CH3 BLOCK DIAGRAM

PROJECT : CH3
Quanta Computer Inc.

CH3 B stage change list

CH3 C stage change list

14.318MHz

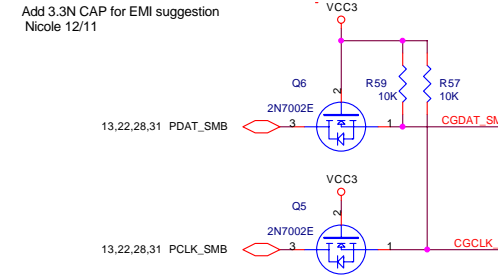
Add 3.3N CAP for EMI suggestion
Nicole 12/11

Add 3.3N CAP for EMI suggestion
Nicole 12/11

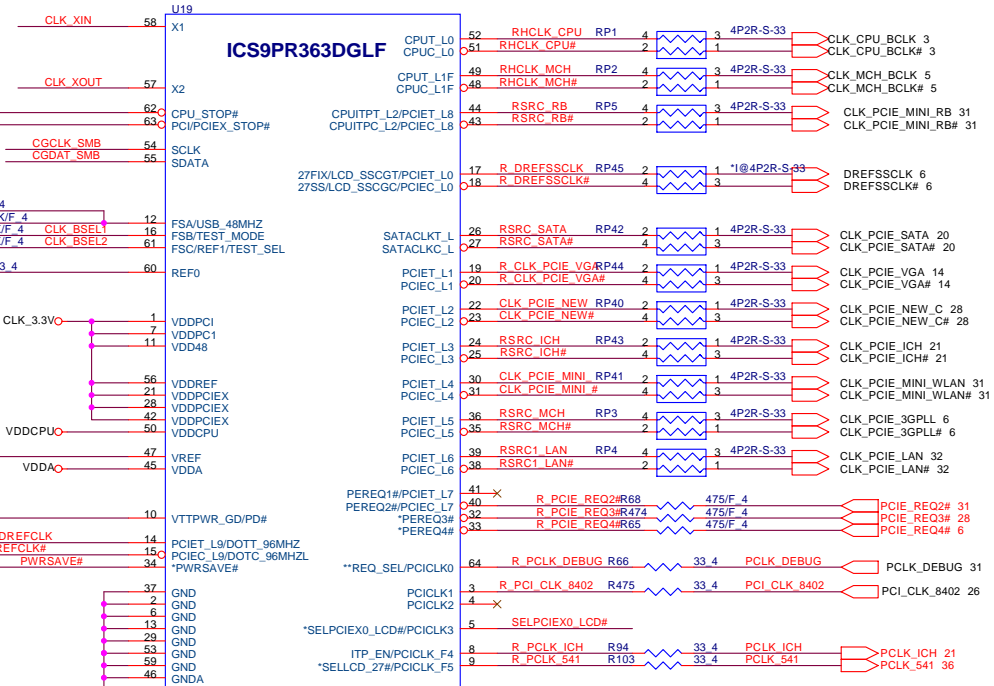
internal build-in 33ohm damping resistor
PN change from B version to D version
nicole 12/01

PC18402

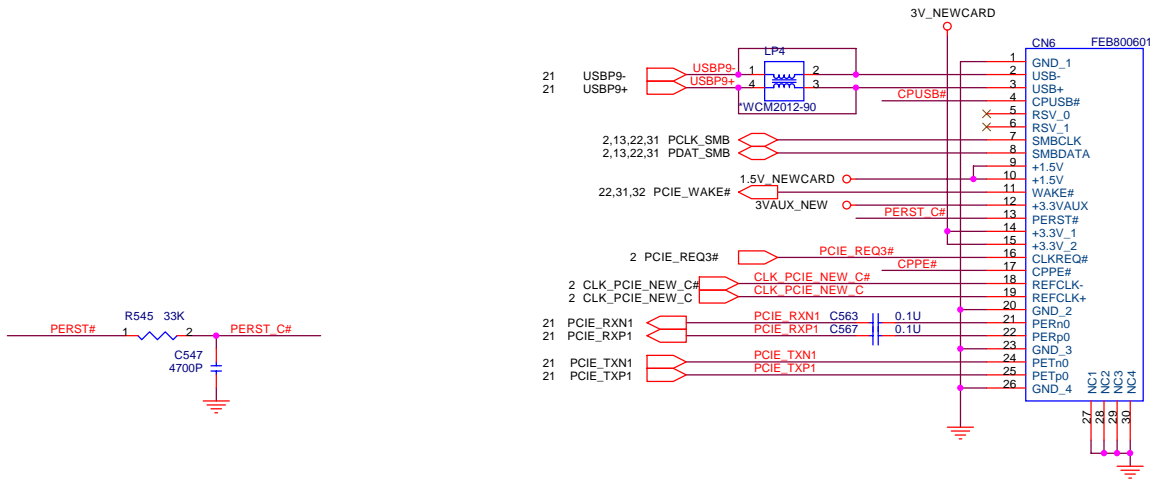
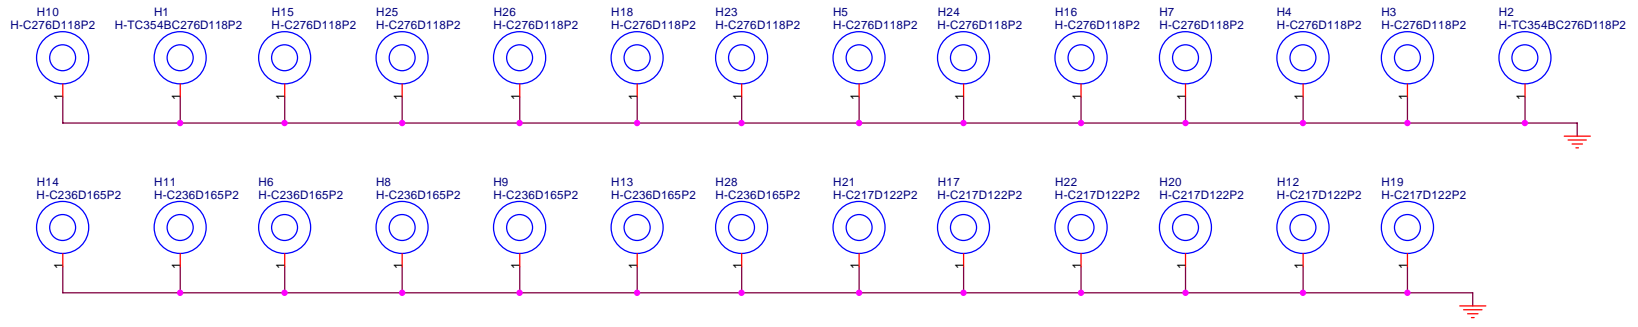
SHDN#, STBY#, PERST# and CPPE# have internal pull-up to AUXIN.
So del R551, R541, R327, R329 nicole 12/11

Del R532 and R556 nicole 12/11

INT Keyboard

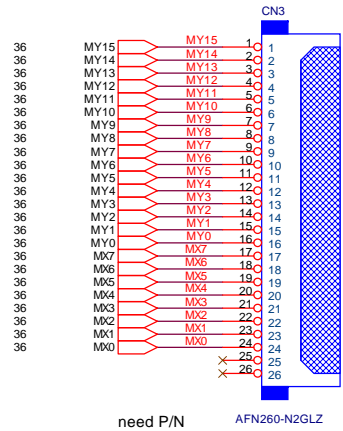
DEL MX[7:0] pull-up to 3VPCU nicole 9/25

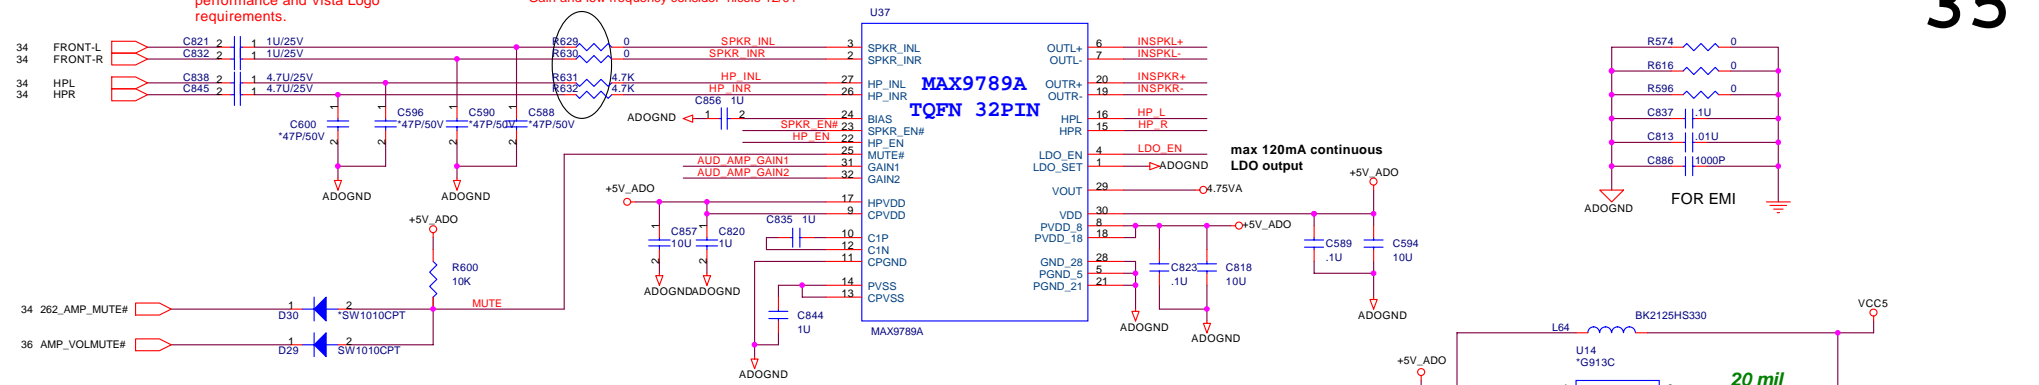
Add for Realtek AE suggestion Gain and low frequency consider nicole 12/01

Headphone out

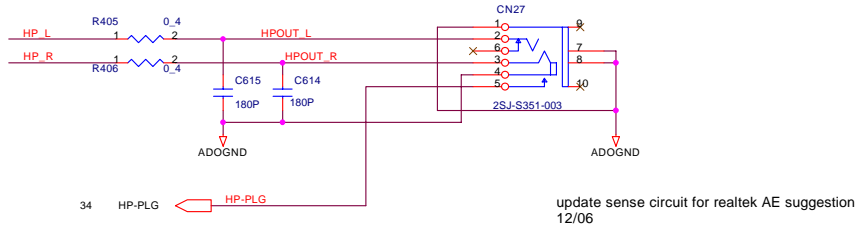
update sense circuit for realtek AE suggestion 12/06

MIC-IN

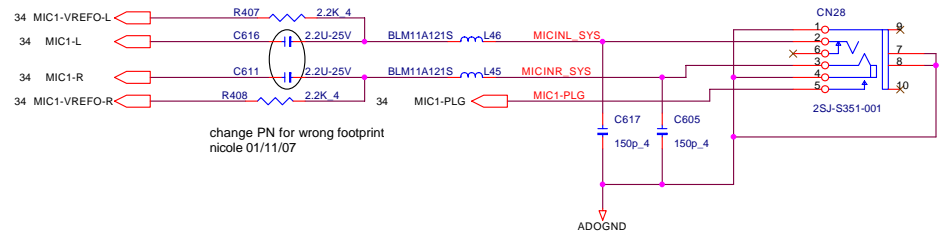
change PN for wrong footprint nicole 01/11/07

| CPU CORE (SC452) | |

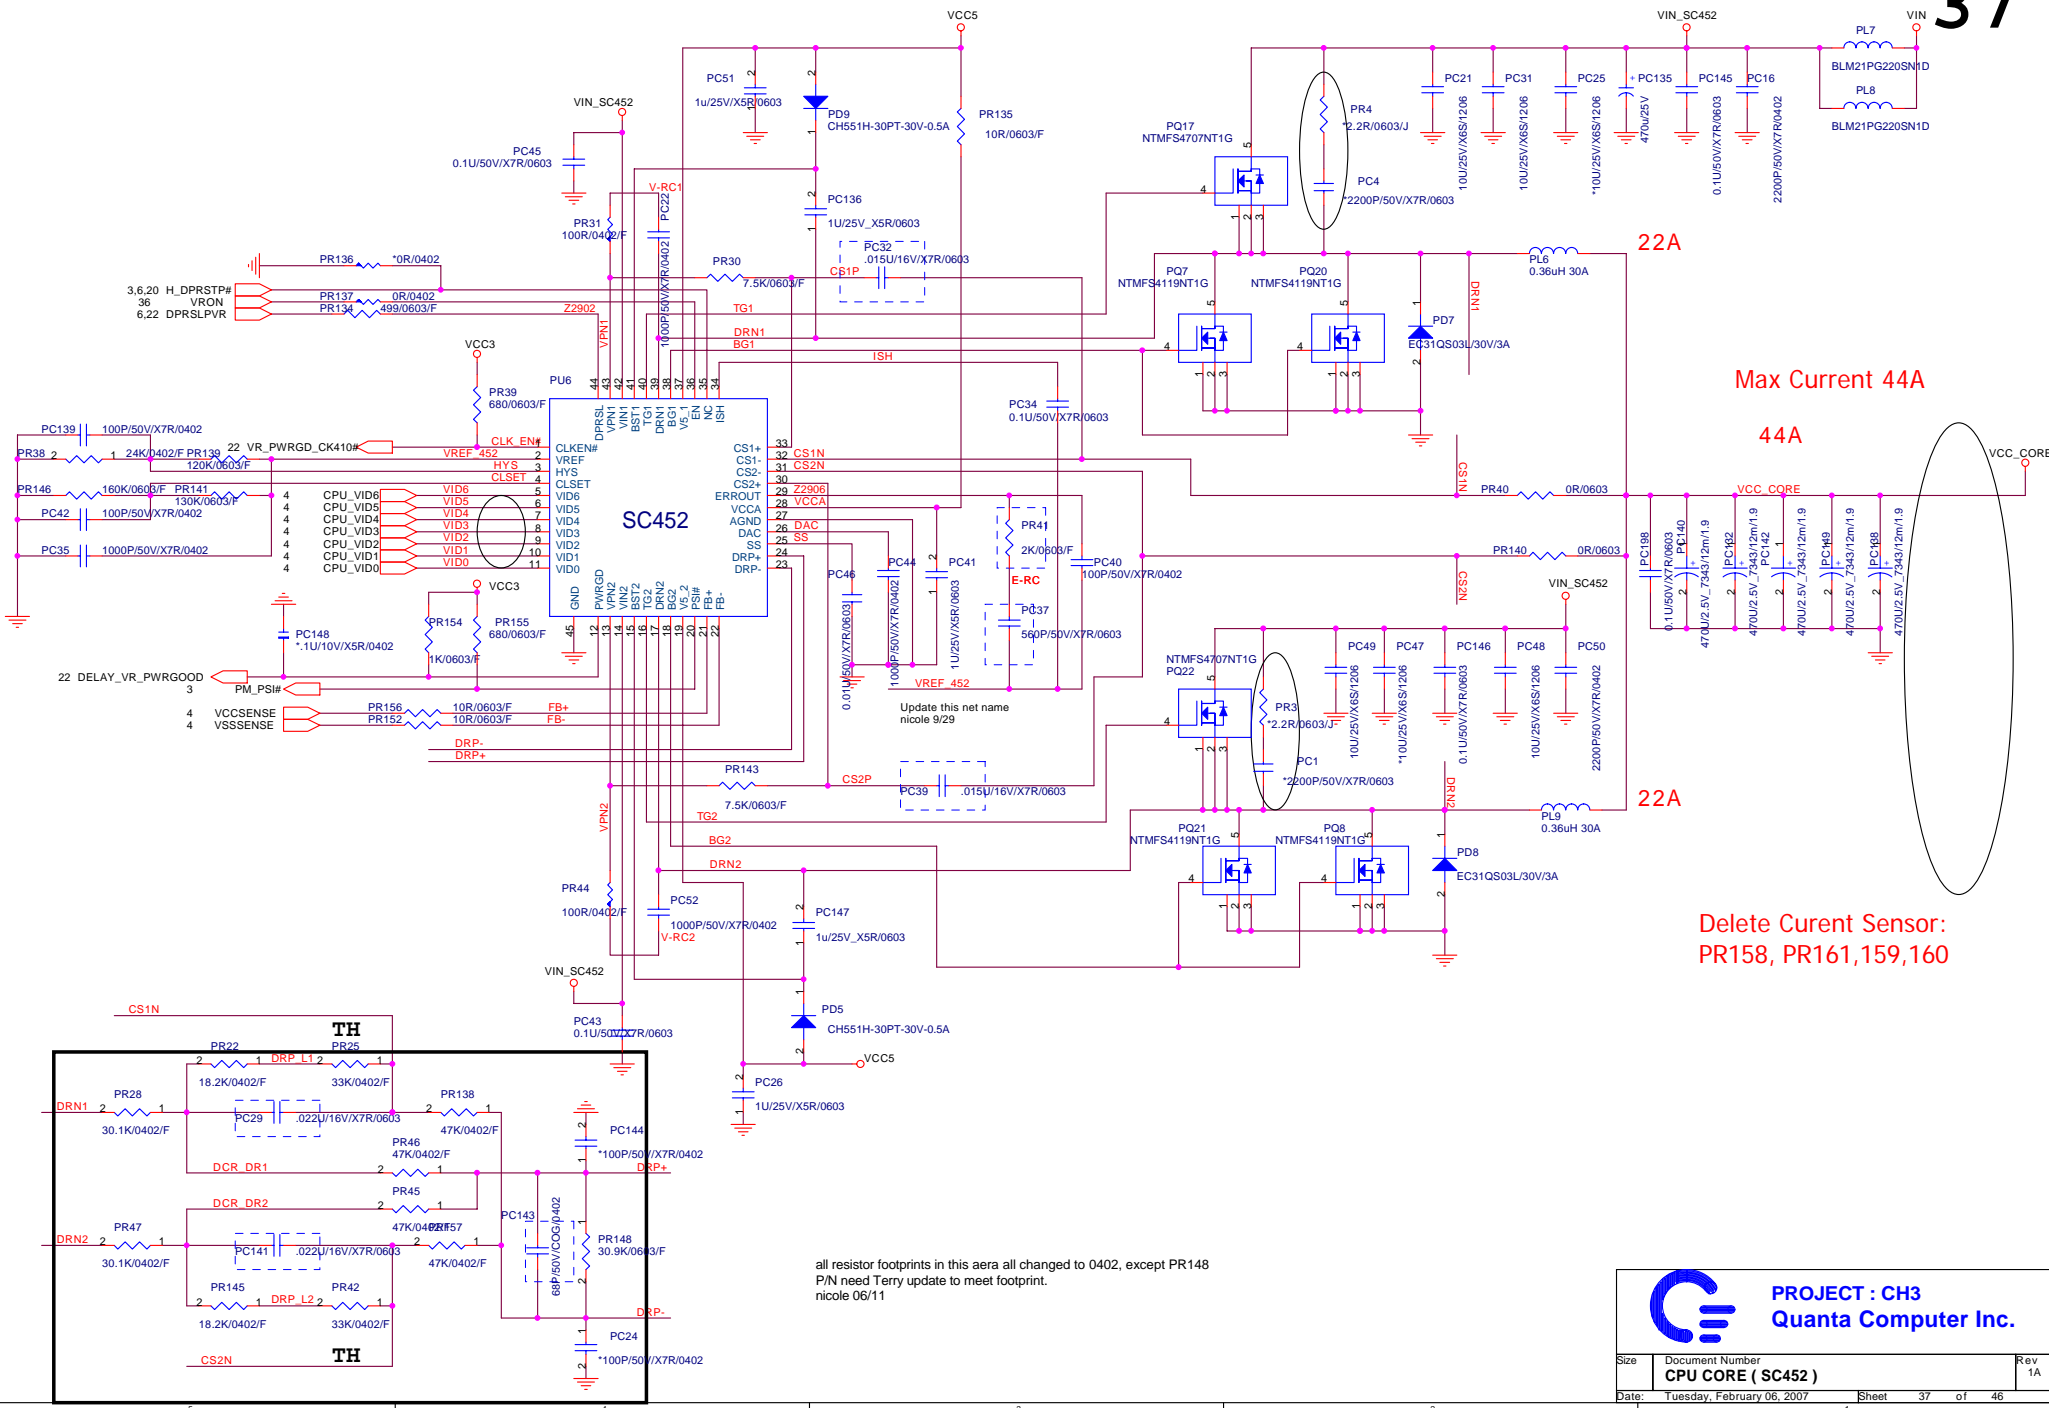
Delete Current Sensor:
PR158, PR161, 159, 160

all resistor footprints in this area all changed to 0402, except PR148
P/N need Terry update to meet footprint.
nicole 06/11

Battery Connector

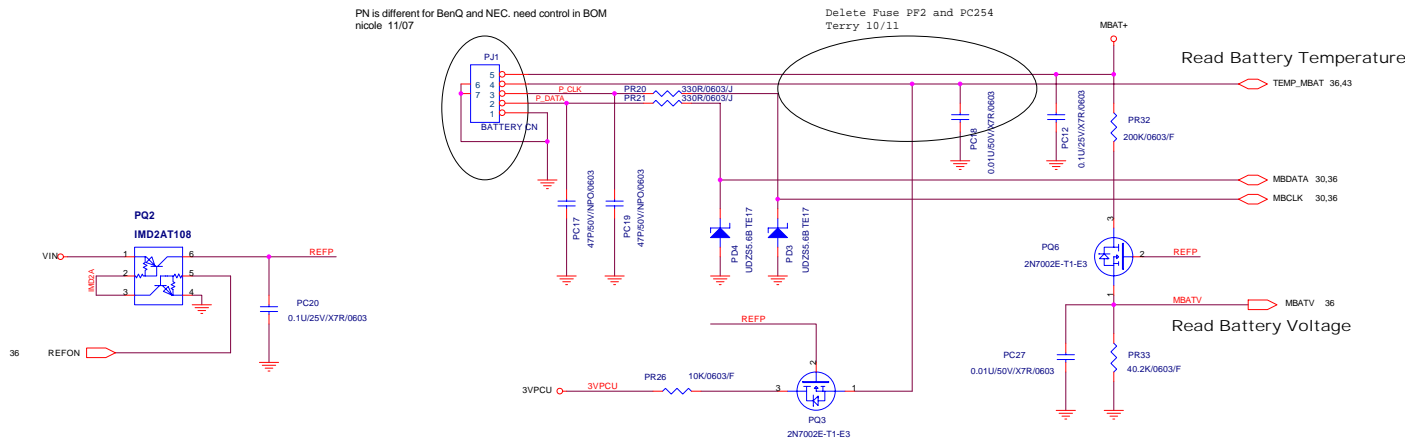
PN is different for BenQ and NEC. need control in BOM
nicole 11/07

Delete Fuse PF2 and PC254
Terry 10/11
